Docket No. 50-293

PILGRIM NUCLEAR POWER STATION

Amendment No. 13
License No. DPR-35

CHANGE NO. 15 TO THE TECHNICAL SPECIFICATIONS

Figure 6.2.1
 Boston Edison Company — Organization for Operation
 of Pilgrim I

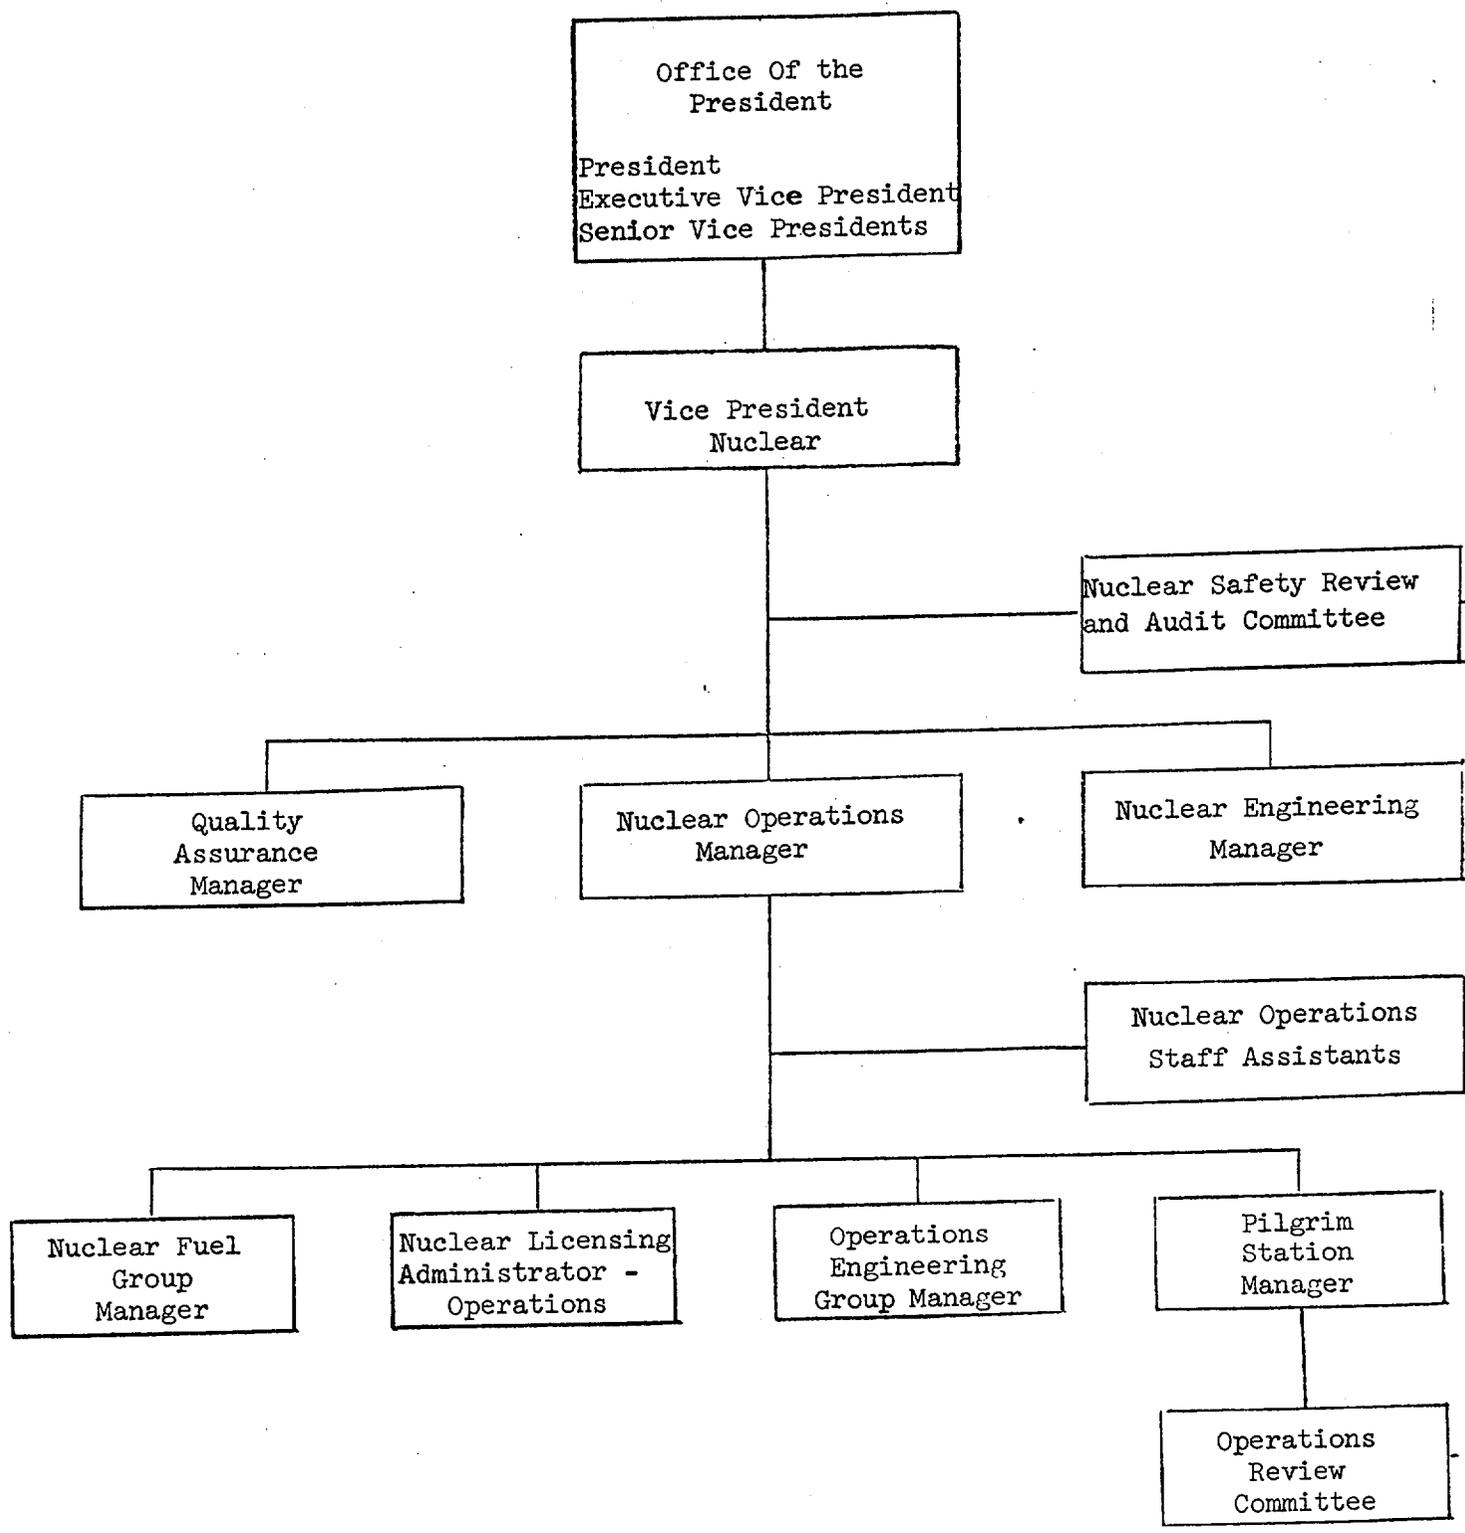
The EECo Corporate and Station Manager changes allow improved communication between the Corporate management and the Station Manager and augments the station organization by the addition of new positions in the areas of waste management, nuclear training, outage planning, health physics supervision, performance engineering and material control. These changes are acceptable to the staff.

The Company organization for station management and technical support shall be as shown on Figure 6.2.1.
